BEFORE HEARING COMMISSIONERS
IN THE WESTERN BAY OF PLENTY DISTRICT

IN THE MATTER OF an application for resource consent to authorise
four existing industrial activities within part of the Te Puna
Business Park structure plan area, for a term of two years

REPLY EVIDENCE OF JUSTINE WILTON

Figure 7: Access layout for subject application, provided in S92 information, May 2023.

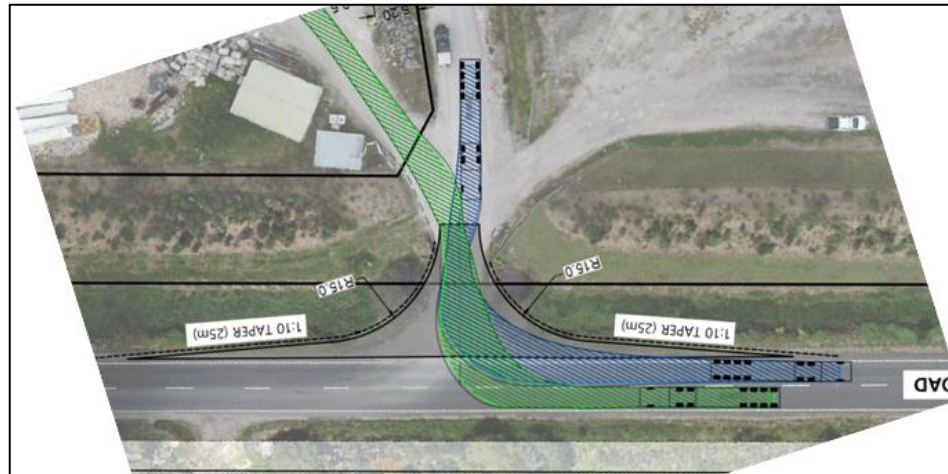
28. Mr Harrison describes the proposed access as a (2007) Diagram D without widening opposite the access. However, without the widening, it is not a (2007) Diagram D because the widening is an integral part of the layout.

31. The picture above doesn't look like 2007 Diagram D. The similarities it has with 2007 Diagram D are the same side tapers and the flare radius. The differences are that driveway width appears to be narrower than Diagram D (5m wide instead of 6m) and there is no widening opposite the access.

Figure 16: Tracking curve and proposed new markings on Te Puna Station Road. Drawing 423022 CIV D001 from S92 information.

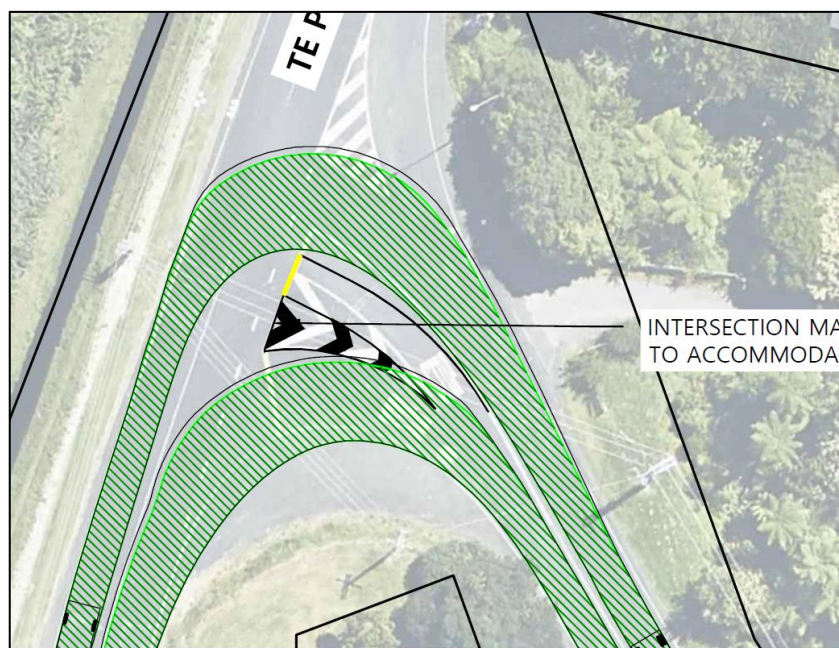
90. The applicant has proposed mitigation for effect f – the proposal is to shift the centreline of Te Puna Station Road so that the inbound HCV does not have to track over the right-out lane as shown in the picture below:

91. This might be acceptable subject to the tracking for the HCV right turn out being satisfied. The right turn out must be checked because shifting the centreline might adversely affect the right turn out, especially for other HCV drivers. Note also that due to the inbound track swinging into the left turn slip (from Te Puna Road), the flush island should be pulled back⁷.
